STATE OF CONNECTICUT
CONNECTICUT SITING COUNCIL

IN RE:	:	
	:	
PETITION OF PAWCATUCK SOLAR	:	PETITION NO. 1345
CENTER, LLC FOR A DECLARATORY	:	
RULING THAT A CERTIFICATE OF	:	
ENVIRONMENTAL COMPATIBILITY AND	:	
PUBLIC NEED IS NOT REQUIRED FOR THE	:	
CONSTRUCTION, OPERATION AND	:	
MAINTENANCE OF A 15 MW AC SOLAR	:	
PHOTOVOLTAIC PROJECT ON ELLA	:	
WHEELER ROAD IN NORTH STONINGTON,	:	
CONNECTICUT	:	AUGUST 22, 2018

RESPONSES OF PAWCATUCK SOLAR CENTER, LLC
TO CONNECTICUT SITING COUNCIL INTERROGATORIES – SET TWO

PROJECT LAYOUT MAP

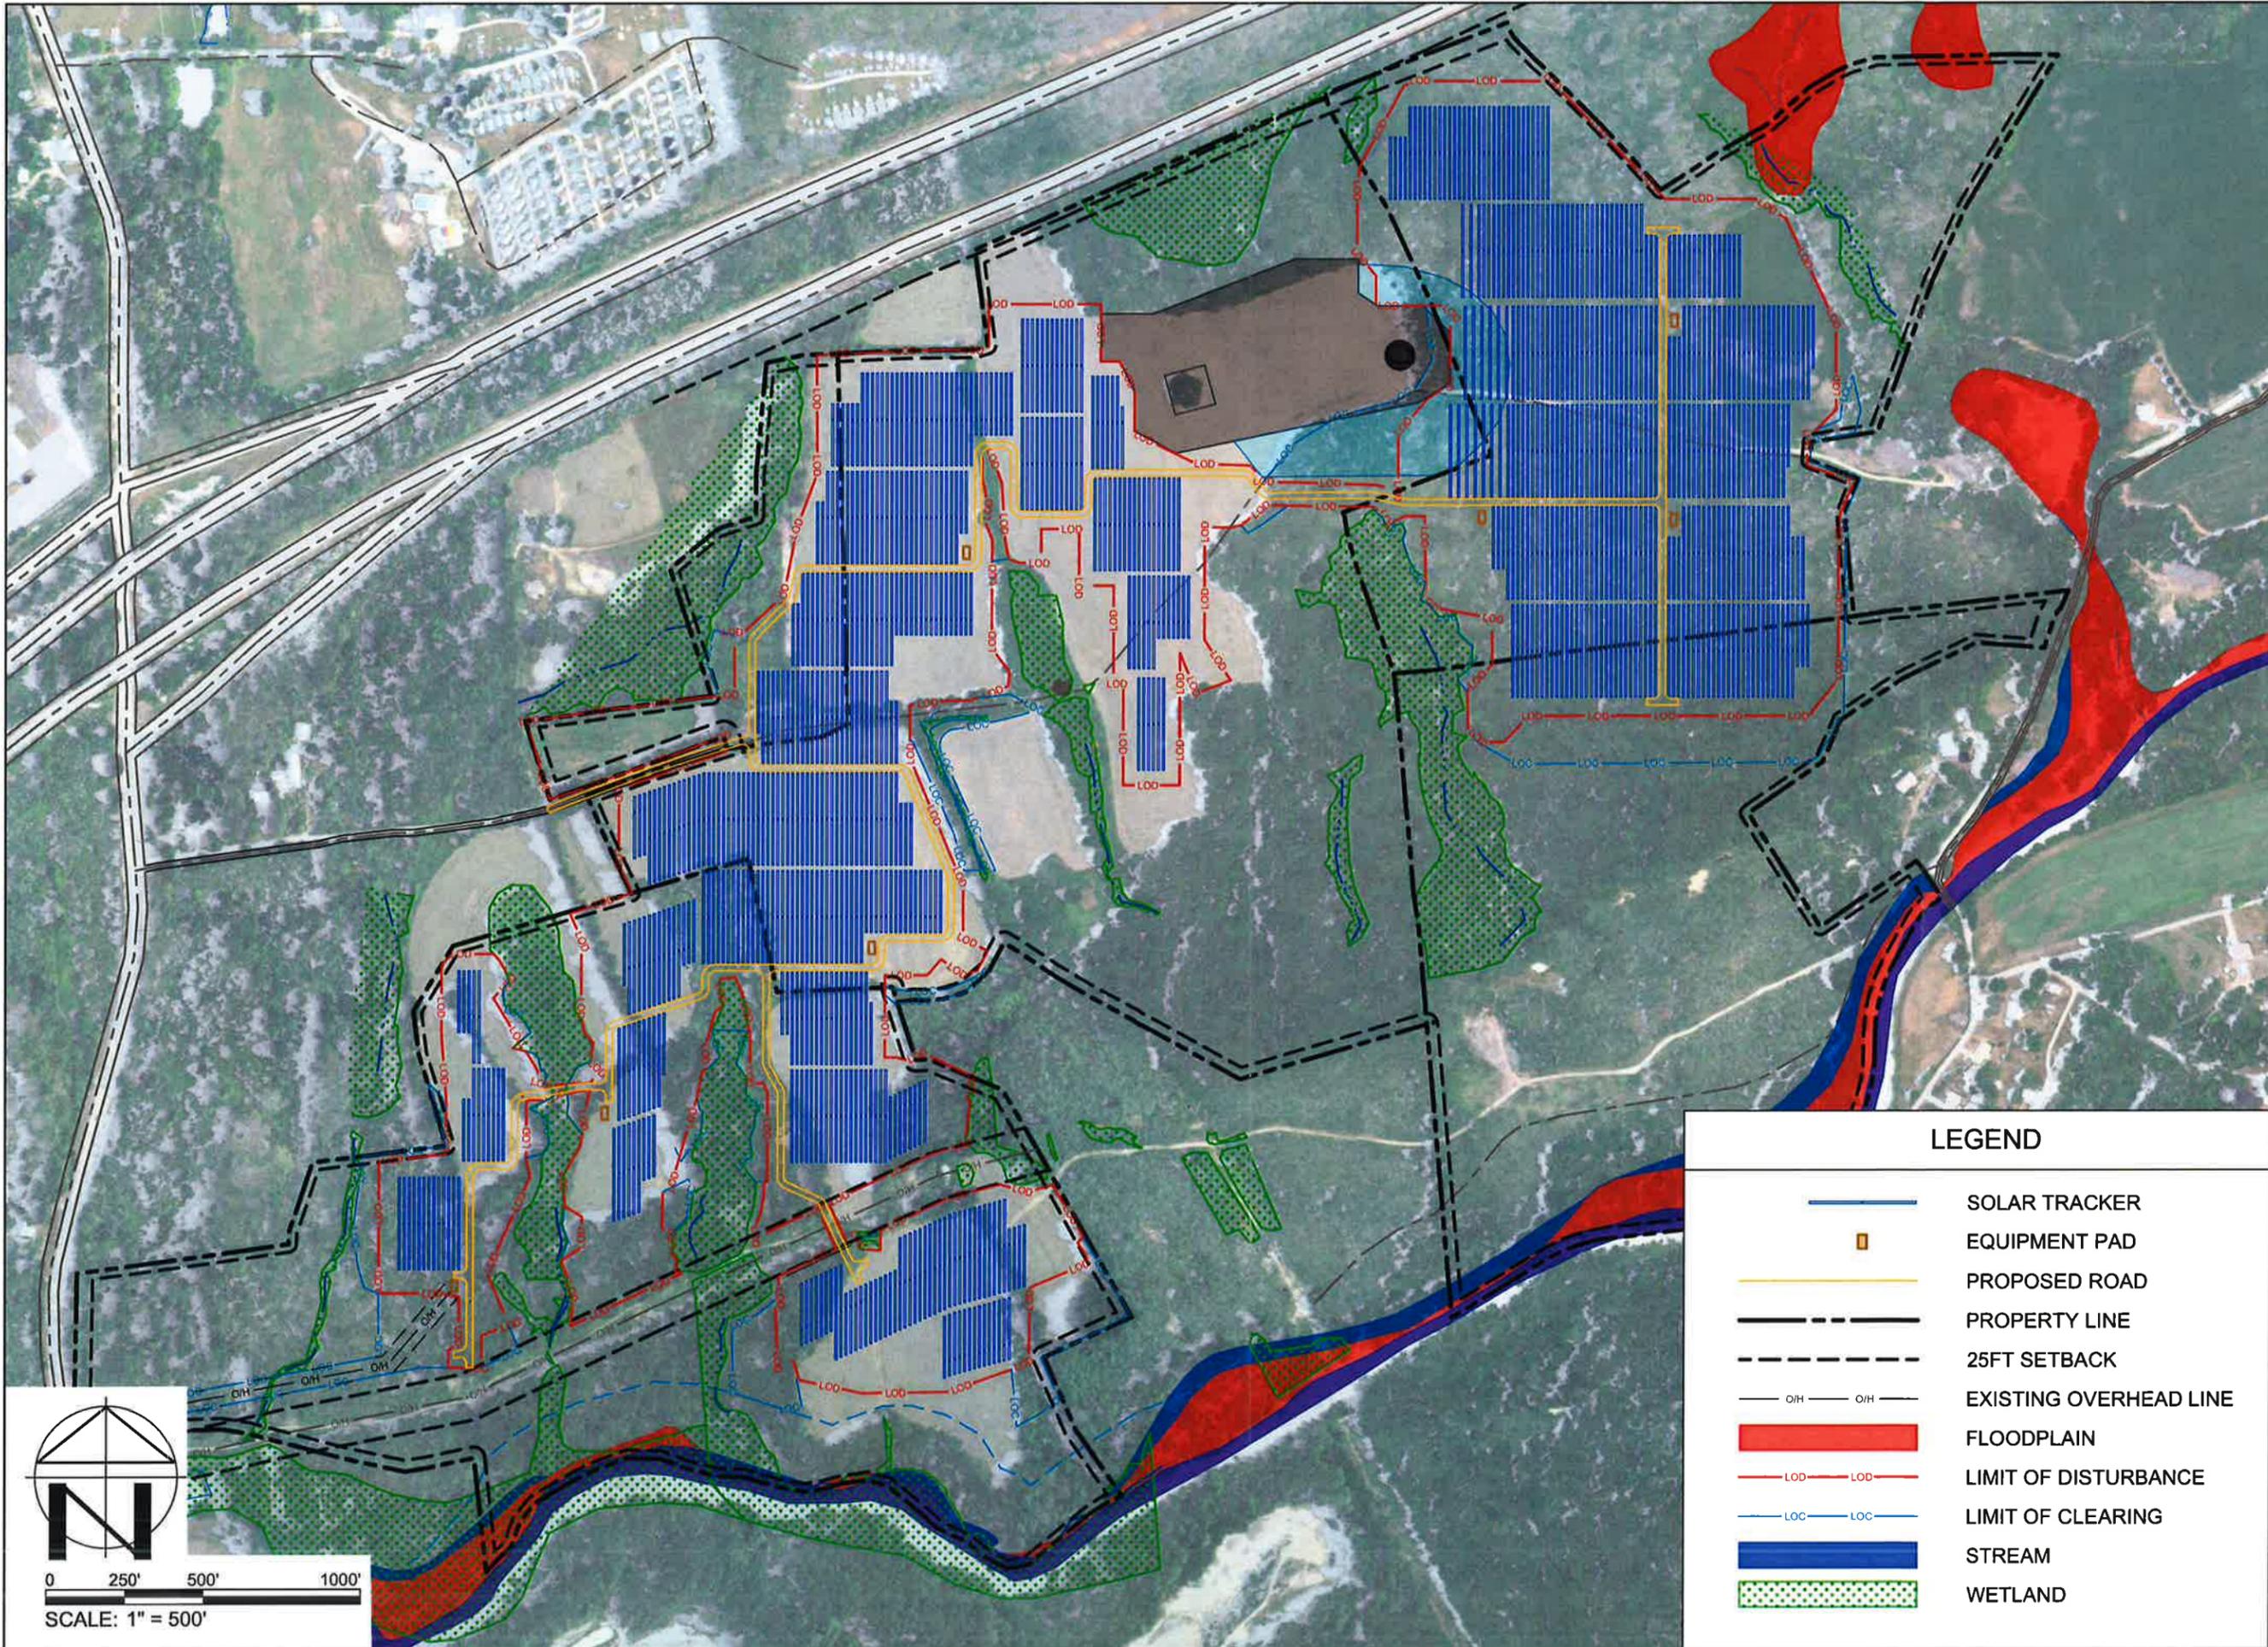
Referring to response to CSC 53, how many acres of clearing are in each of the following:

- a) Wetland 1
- b) Wetland 2
- c) Wetland 5

Can the project be reconfigured to reduce the amount of clearing within wetlands?

- a) Wetland 1 = 2.54 ac.
- b) Wetland 2 = 1.44 ac.
- c) Wetland 5 = 0.85 ac.

It may be possible to reconfigure the site layout and reduce the amount clearing within Wetland areas 1, 2 and 5. The acreage referenced above represents the maximum acreage that would be cleared within these wetland areas.

Following up on conversations between the Petitioner, Council members and Council staff during the site visit, the Petitioner explored ways to revise the site layout to move more of the solar array into the area nearer the vernal pool. This area was identified by members of the Council as being lower value than some of the wetland areas original proposed to be impacted. This change in site layout would result in less overall wetland acreage being impacted by the project. See Attachment 1. If the Siting Council prefers this revised layout, the Petitioner would update its final project drawings as a part of the Development and Management Plan process. The revised layout would result in a significant reduction in the wetland areas to be cleared from 4.83 acres to 0.37 acres.
